INAC Reference
CIDM# 1227672

NWB Reference
#1BR-KEI1722

Our Reference
60579368 (400)

Crown-Indigenous Relations and Northern Affairs Canada – Water Resources Division Technical Review of Type ‘B’ Licence for CAM-E Keith Bay Remediation Project 1BR-KEI1722 - Contaminated Sites Division with Crown-Indigenous Relations and Northern Affairs Canada

Attach: Figure 1

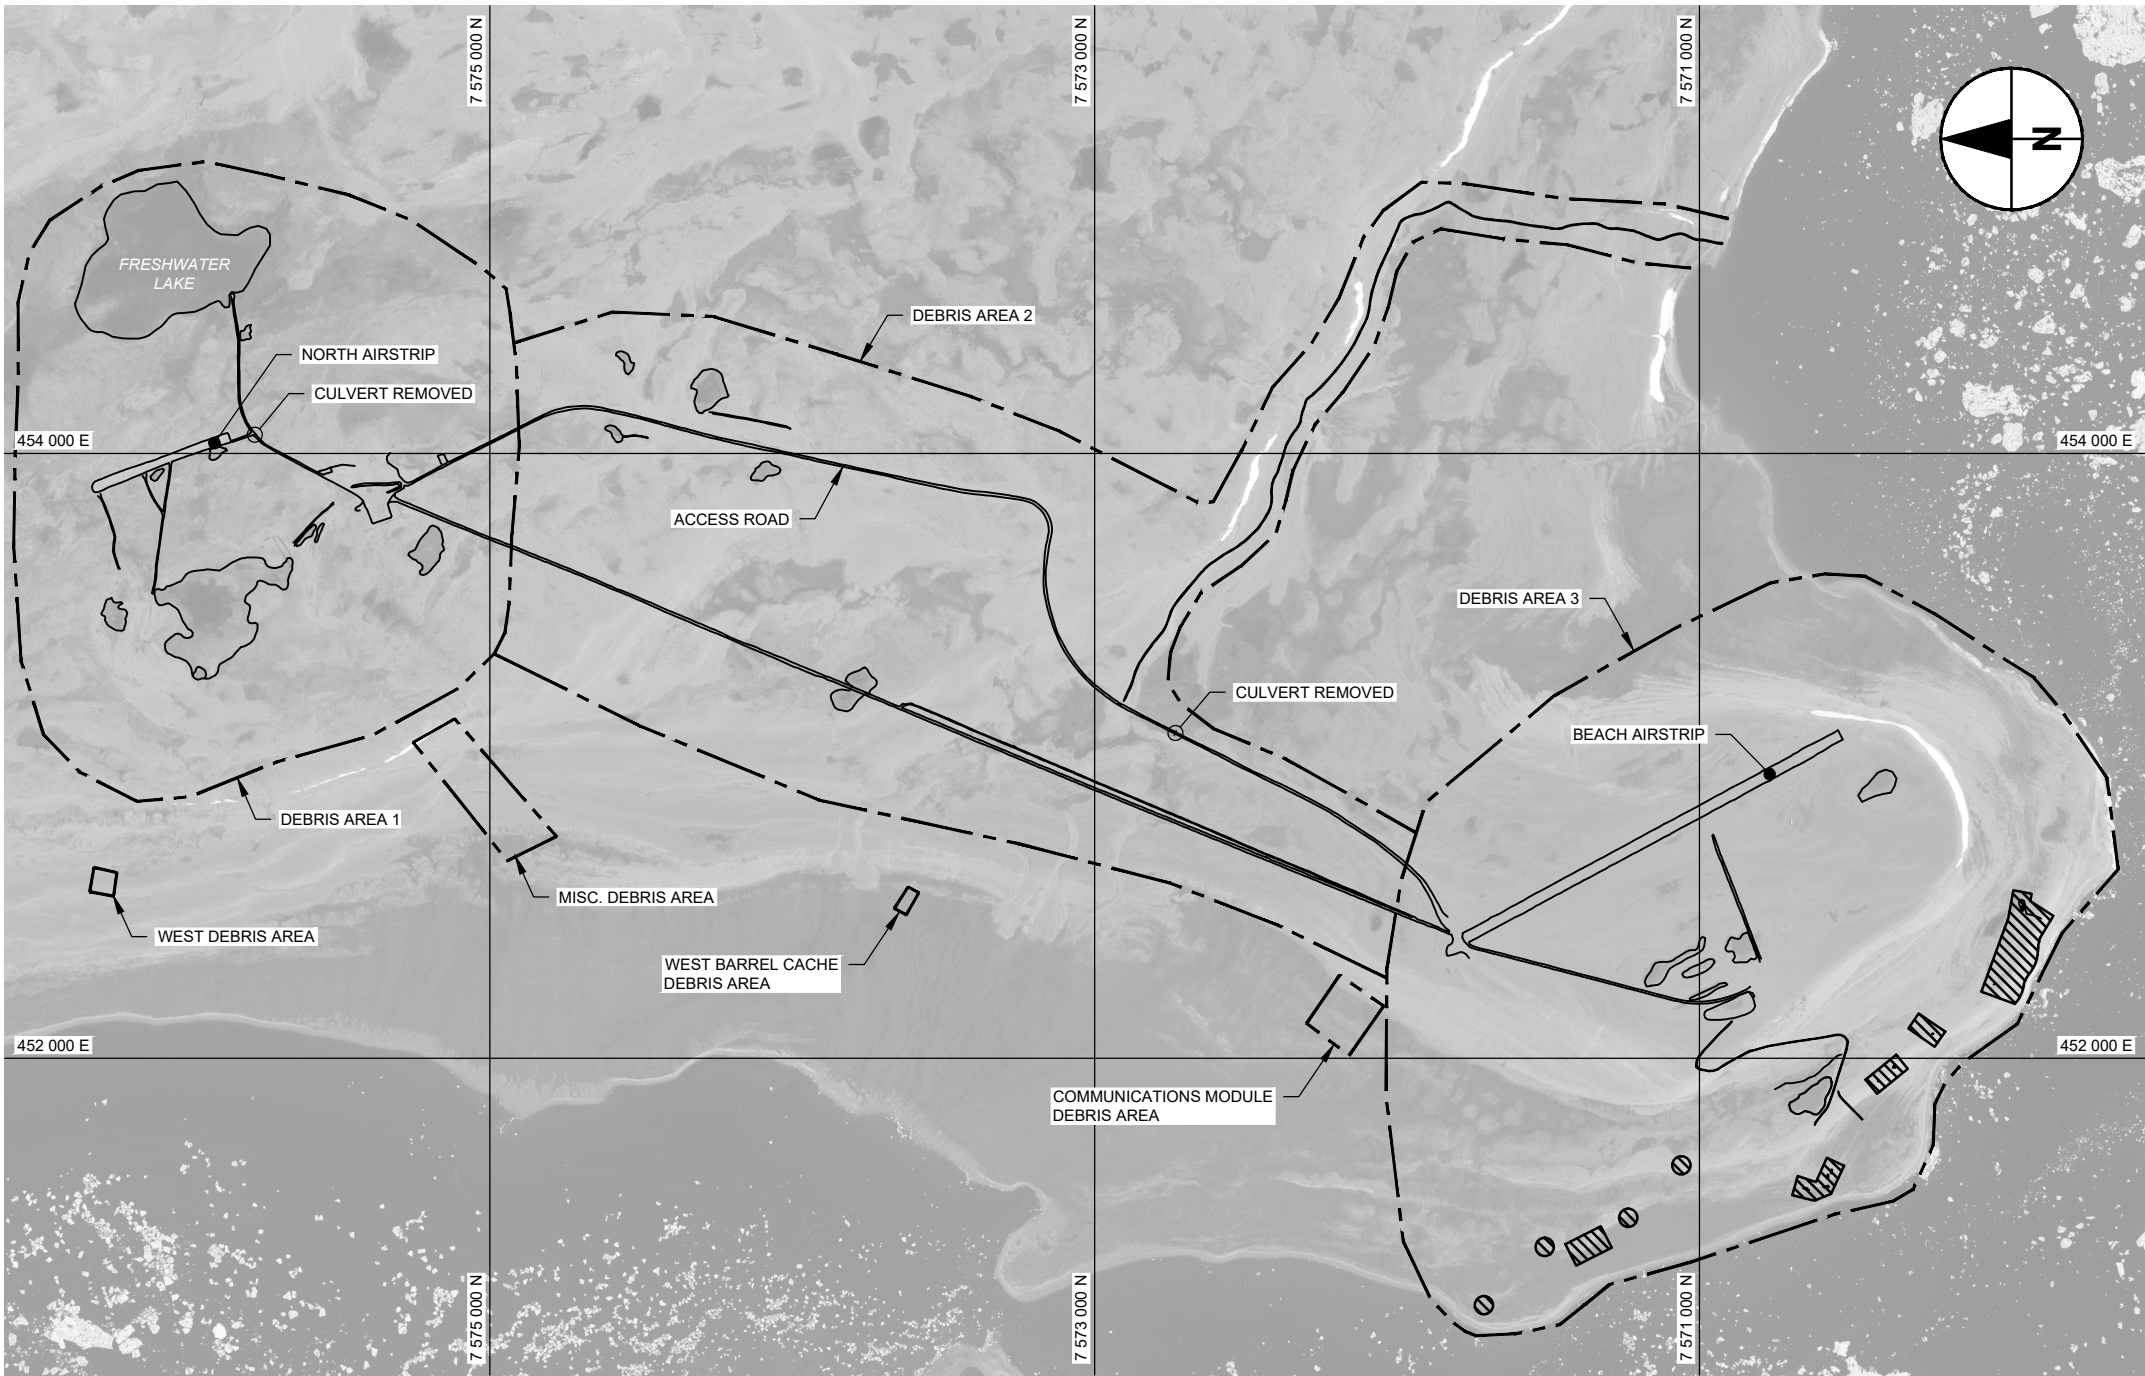
CIRNAC water resource division recommends that design reports for the culvert installation and maps of where the culverts will be installed, as well as how many culverts will be installed for the remediation project, be submitted to the board for review and approval.

Following mobilization to the CAM-E site in June 2017 it was determined by the Contractor that there had not been any significant washout along the main road and the installation of a culvert was not required. To maintain trafficability along the main road, the Contractor placed clean fill from a nearby borrow area into the low area of the main road and graded the fill to match the existing road surface.

During demobilization activities in September 2018, the Contractor removed two existing culverts, one located at the junction of the North Airstrip and the road to Freshwater Lake and one located approximately 0.6 kilometres (km) north of Area 2, as shown in Figure 1. Following removal of the culverts, the side slopes of the remaining roadway were graded to approximately 10 horizontal to 1 vertical to provide a stable channel for drainage and allow vehicle passage, as indicated in the Specifications, Section 31 22 15 – Grading, Clause 3.6.5. No existing culvert was identified at the area of the washout approximately 0.8 km north of Area 2.
